2013 Geotechnical Annual Review, Minto Mine, YT

Minto Explorations Ltd.

SRK Consulting (Canada) Inc.
1CM002.012.005
October 2013

| Job No: 1CM002.012.05 Filename: Minto 2013 Fall Inspection.pptx | Minto Mine | Date: October 2013 | Approved: PHM | Figure: 3 |

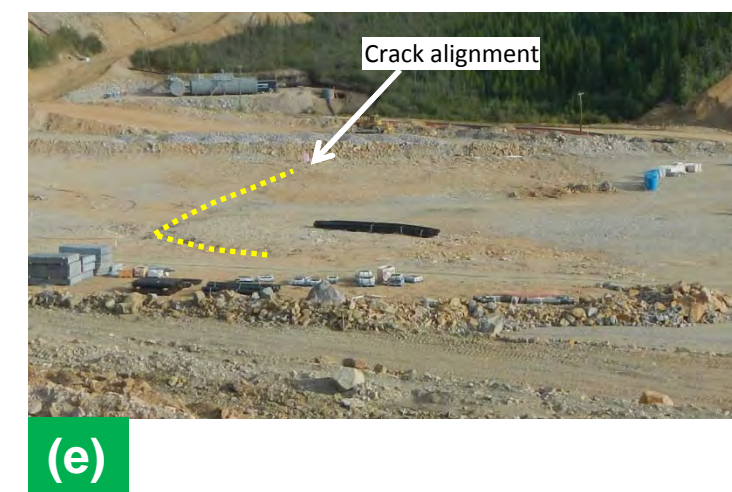
- Photos (c) to (e) show an area of differential settlement and cracking on the Mill Valley Fill Extension.
 - The area of settlement at the south end of the crack measures 15m x 22 m with a depth of up to approximately 0.6 m.

- The settlement and cracking is believed to be caused by differential settlement between the two lifts placed at different times. The newer lift may be settling within the coarser material at the older outer bench face. If the new lift was placed during winter, snow may have also been present on the slope that has now melted.

- The settlement area should be graded and filled in.
